Re: ENERGY STAR Luminaires Draft 2 Comments

Page 32 / Solid-State

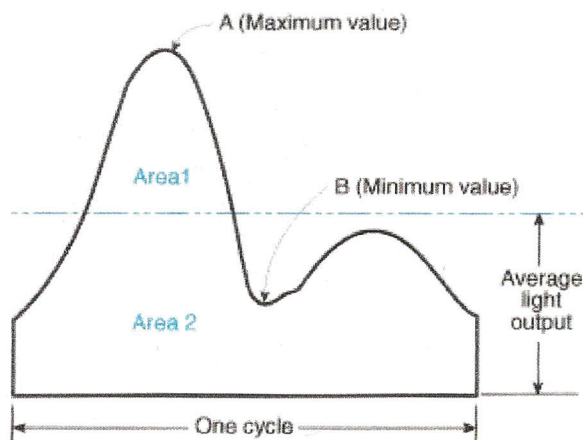
Issue One: The use of modulation depth is an obsolete standard, abandoned by the IES for a more meaningful Flicker Index. Flicker Index is defined by the relationship of luminance area above average to total area as follows (from IES Handbook 9):

Calculation: $\text{Area 1} / (\text{Area 1} + \text{Area 2}) = \text{Flicker Index}$

A flicker Index of “0” is the highest rating achievable, with a rating of “1” being the worst. Photometric data collected by LTL (Grather 2009) indicates an incandescent lamp has a flicker index of roughly .0194, while a Metal Halide Lamp has a flicker index of 0.1398, and a T12 fluorescent lamp on magnetic ballast operates with a flicker index of 0.0897.

Based on this, a maximum Flicker Index of 0.130 should be established.
